DEVELOPMENT APPLICATION ASSESSMENT REPORT

Application Number:	DA2024/0303
---------------------	-------------

Responsible Officer:	Anne-Marie Young
Land to be developed (Address):	Lot 5 DP 222134, 337 Lower Plateau Road BILGOLA PLATEAU NSW 2107
Proposed Development:	Demolition of existing structures, removal of trees and subdivision of one lot into three lots.
Zoning:	C4 Environmental Living
Development Permissible:	Yes
Existing Use Rights:	No
Consent Authority:	Northern Beaches Council
Delegation Level:	NBLPP
Land and Environment Court Action:	No
Applicant:	Sean Clive Gartner

Figure 1: Southern elevation of the concept dwelling for lot 1 showing the building envelope breach in red.

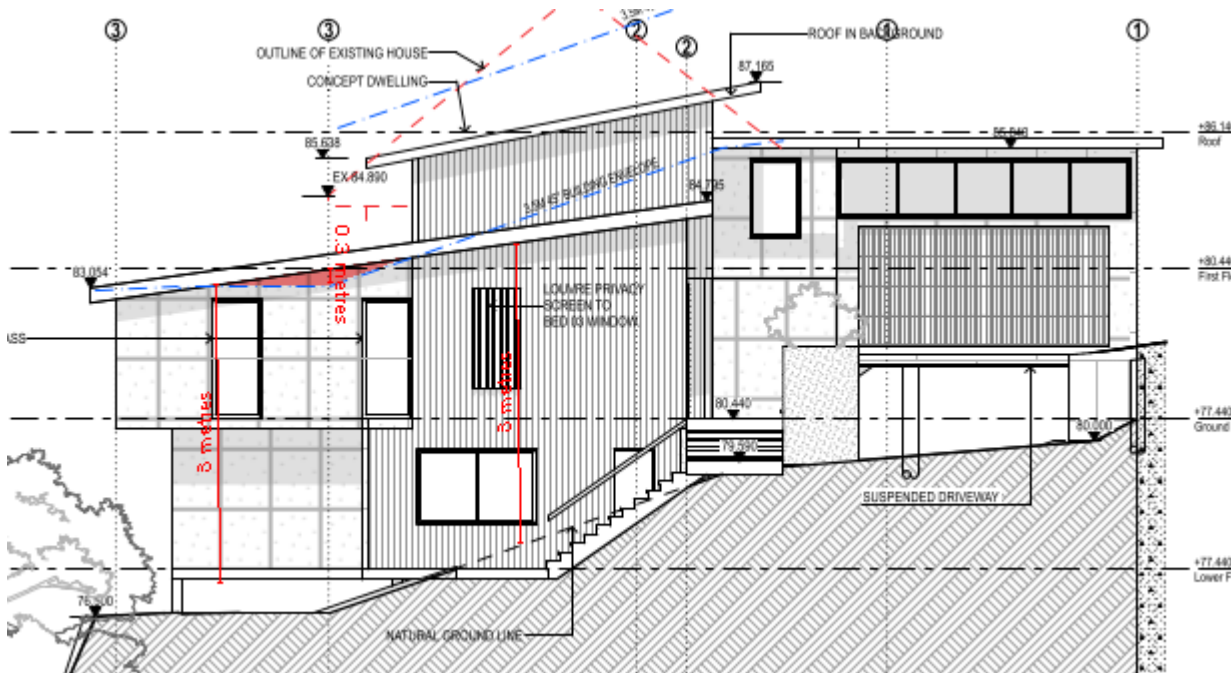
The following minor building envelope breach a triangular area (0.3 metres in height x 3.3 metres in length), is noted on the southern elevation of concept dwelling on lot 1, refer to image below.

Figure 2: North elevation of the concept dwelling for lot 3 showing the building envelope breach in red.

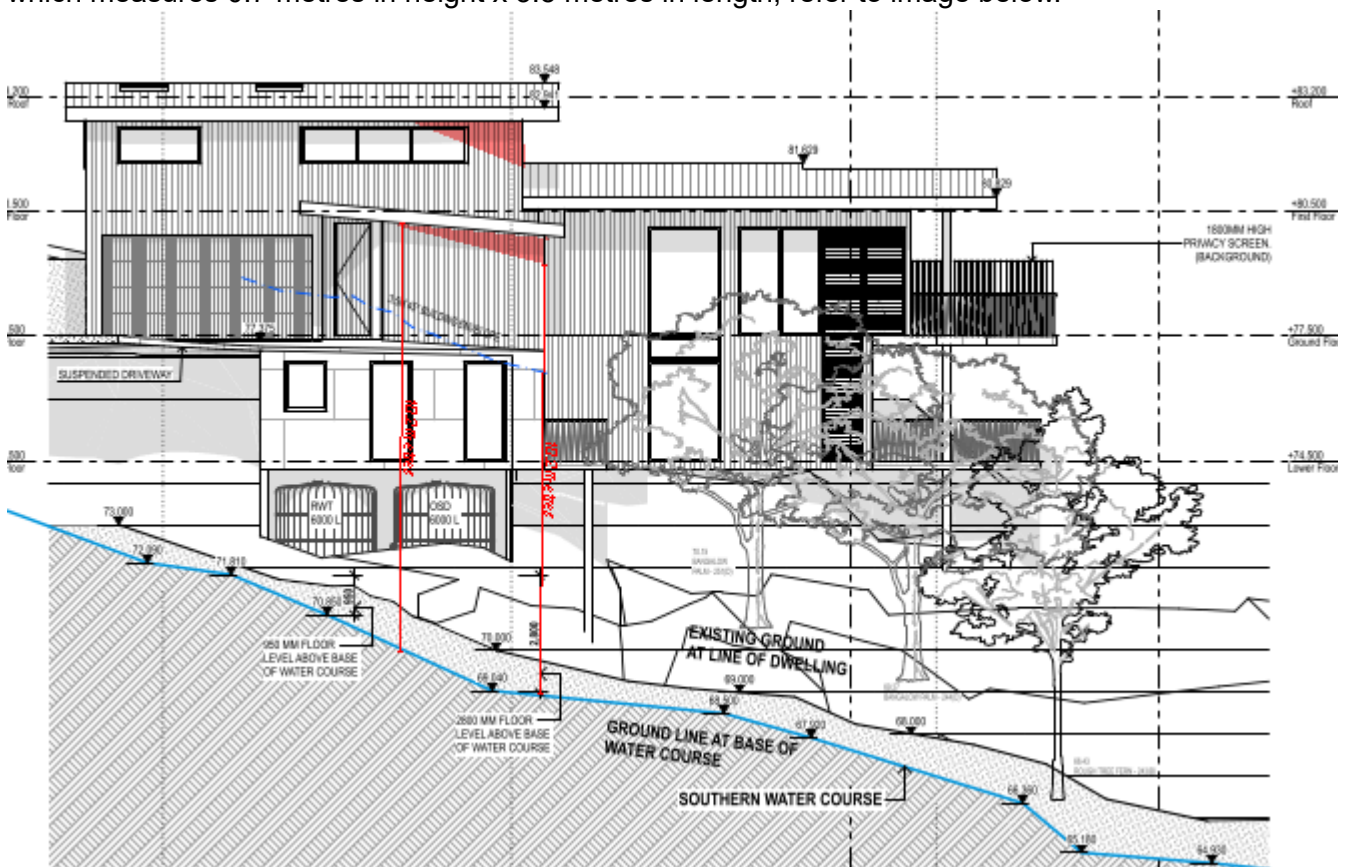
The proposal has been amended to reduce the extent of the envelope breach on the north elevation of the dwelling on lot 3 to a minor triangular area on the first floor which measures 1.0 metres in height x 2.7 metres in length and a minor triangular area which relates to the ground level study and entry which measures 0.7 metres in height x 3.5 metres in length, refer to image below.
